## Model 250R/RX

## Clutch

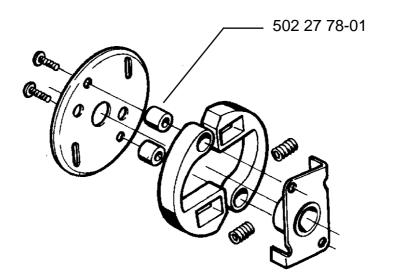
A degree of clutch slip is caused when the clutch is exposed to heavy loading, e.g. when using the trimmer head with heavy gauge cord. This creates heat which can damage the Teflon bushings on the clutch shoes. There is a new bushing now available as an option that is manufactured of bearing bronze and can withstand a higher temperature.

**New Ref. No. Description** 502 27 78-01 Bronze bushing
